**6.1** **80 WESTBURY STREET, BALACLAVA**  
**LOCATION/ADDRESS:** 80 WESTBURY STREET, BALACLAVA  
**EXECUTIVE MEMBER:** LILI ROSIC, ACTING GENERAL MANAGER PLACE STRATEGY AND DEVELOPMENT  
**PREPARED BY:** KATHRYN POUND, PRINCIPAL URBAN PLANNER

1.1 To determine Council's position in the upcoming Victorian Civil and Administrative Tribunal (VCAT) hearing for Planning permit application 1165/2016.

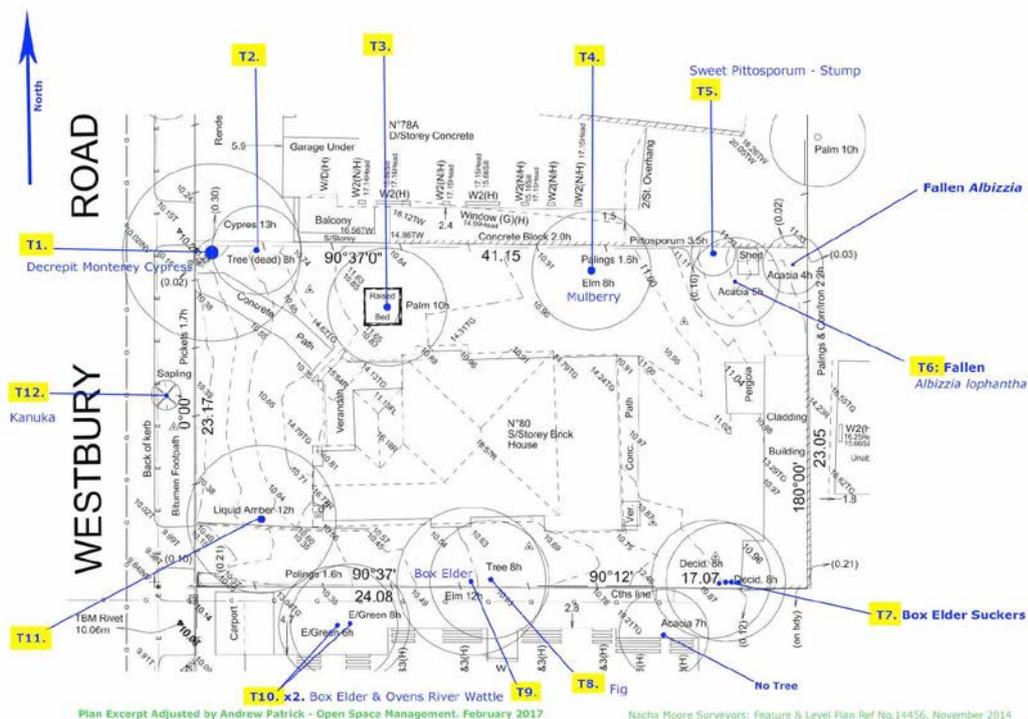
- 12.21 The building is proposed to be oriented to Westbury Street, with both pedestrian and vehicle access off it. Several balconies and terraces and numerous habitable room windows and doors face the street, providing passive surveillance and activation of the street at the upper floor levels.

- 12.22 1.5 m high fencing is proposed along the frontage, which would provide partial privacy to the courtyards and habitable room windows of the two ground floor dwellings which face the street. This is more appropriate than having secluded space behind a 1.8 m high front fence, since it provides better integration with the street.
- 12.23 The proposed vehicle access would be via the existing single width crossover (which may need to be slightly modified to align with the driveway). This is an appropriate arrangement with regard to minimising impacts on on-street parking and street trees.
- 12.24 The basement car parking would not be visible from the street, which would be satisfactory.
